STATE OF NORTH CAROLINA
DEPARTMENT OF TRANSPORTATION

Subject: Application for Section 404 Nationwide 14, Section 401 Water Quality Certification, and Tar-Pamlico Riparian Buffer Authorization for the construction of US 301 Bypass Improvements between NC 43/48 (Benvenue Road) to SR 1836 (May Drive) in Nash County. TIP No. U-3330. Debit \$570 from WBS 36596.1.2.

The North Carolina Department of Transportation (NCDOT) proposes to widen the US 301 Bypass in Rocky Mount from Benvenue Road to May Drive in Nash County, NC.

Plan Sheet 6 – The bridge crossing

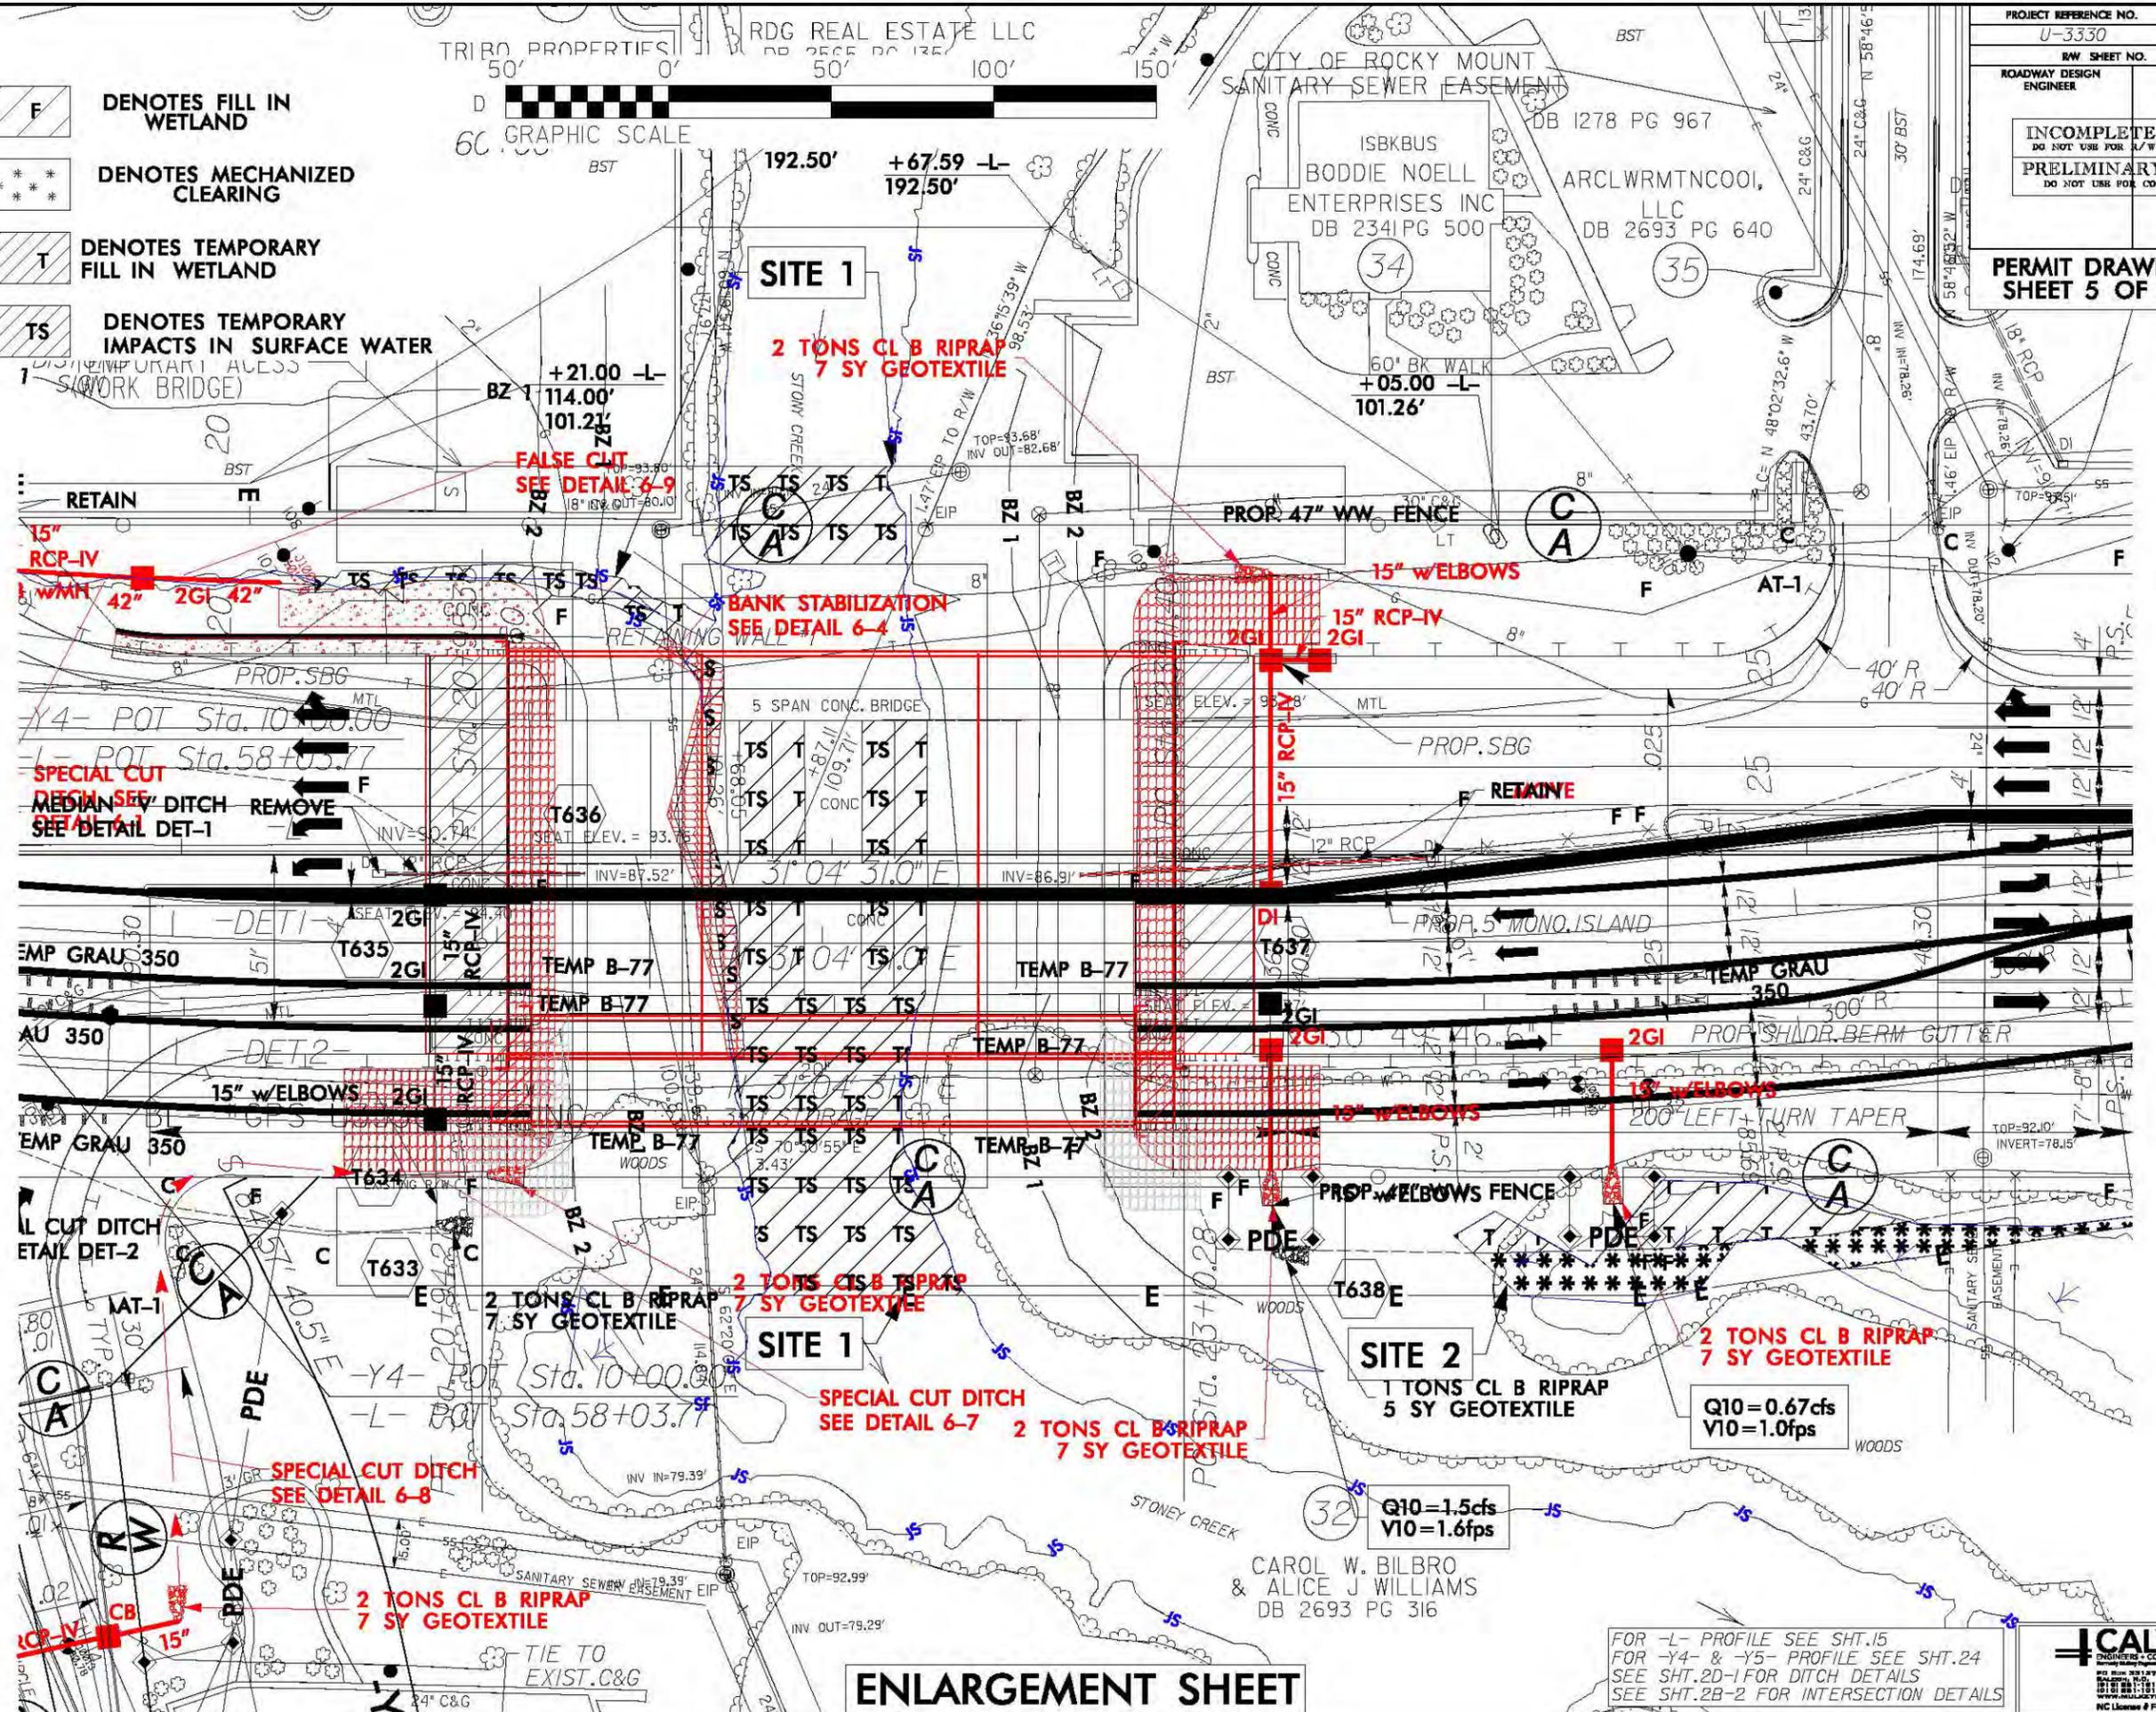
Site 5 - Plan Sheet 6 – Stony Creek - Bridge Crossing

- CALYX explained that the permanent bridge spans the creek. Since the 4B meeting, due to constructability, phased construction of the bridge is no longer possible, therefore a detour with temporary bridge located to the south of US 301 will be utilized. NCDOT Structures provided Temporary Causeway/Work Bridge drawings which were used to show the temporary impacts accordingly.

- Add buffer impacts to the northwest quadrant of the bridge crossing.
- Turn off Bridge approach slab hatching.
- Add Detail of Temporary Causeway / Work Bridge. It was suggested to simply add the sheets (provided by Structures which shows these actual locations) to the permit drawing set.

- Include/show temporary impacts for entire JS that is between –L- and Bojangles.
- CALYX to relook at the need for concrete slope protection between the proposed retaining wall and bridge at –L- 59+50 LT. Discussion between CALYX and Division 4 Construction staff are pending.

- Add 5'-10' temporary impacts around existing bents to be removed.
- Show temporary buffer impacts on the south side of the bridge in the area of the temporary bridge.
- The Division requested that stream bank stabilization be added on the south side of the bridge from drip line to drip line.

PROJECT REFERENCE NO. U-3330	SHEET NO. 6
R/W SHEET NO.	HYDRAULICS ENGINEER
ROADWAY DESIGN ENGINEER	
INCOMPLETE PLANS DO NOT USE FOR A/W ACQUISITION PRELIMINARY PLANS DO NOT USE FOR CONSTRUCTION	
PERMIT DRAWING SHEET 6 OF 28

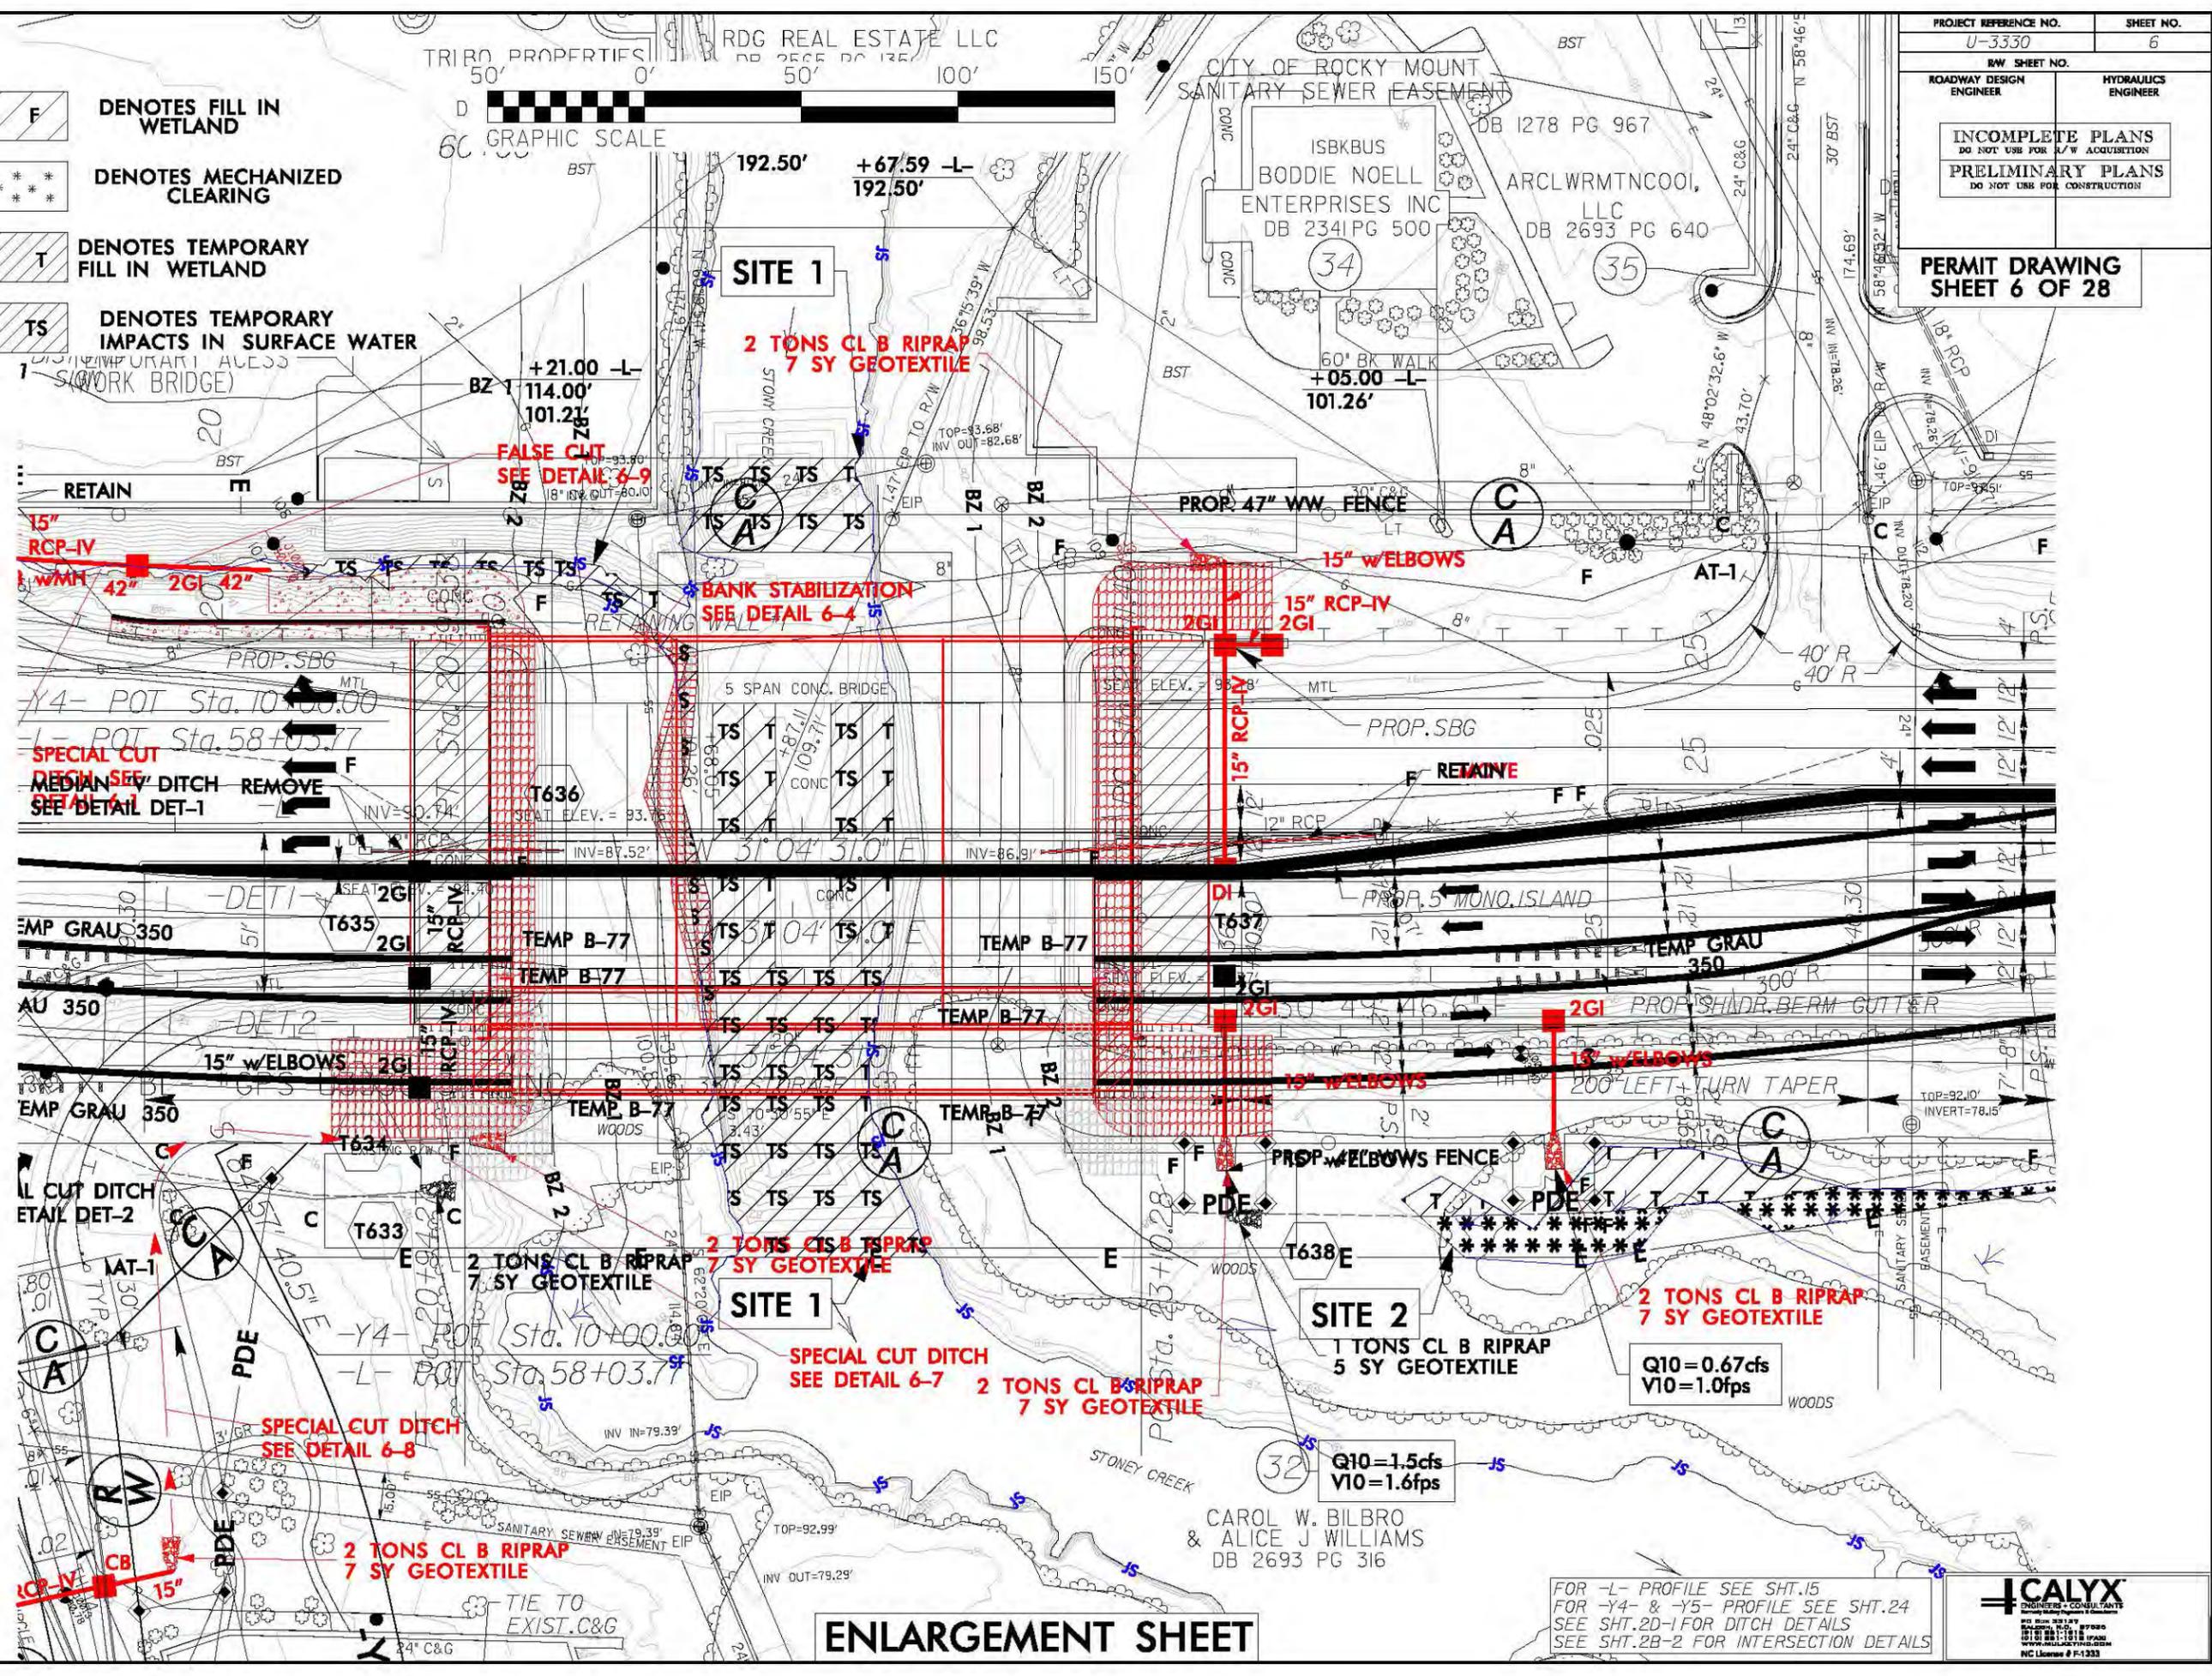
Plan Sheet 7 – 42” Pipe outfall and large wetlands

- Make sure that impacts are accounted for when going outside control of access with regards to easements.
- Change the PSH to rock slash pad due to the inaccessible location of outlet of pipe. This is for shoulder berm gutter outlet, behind the guardrail.
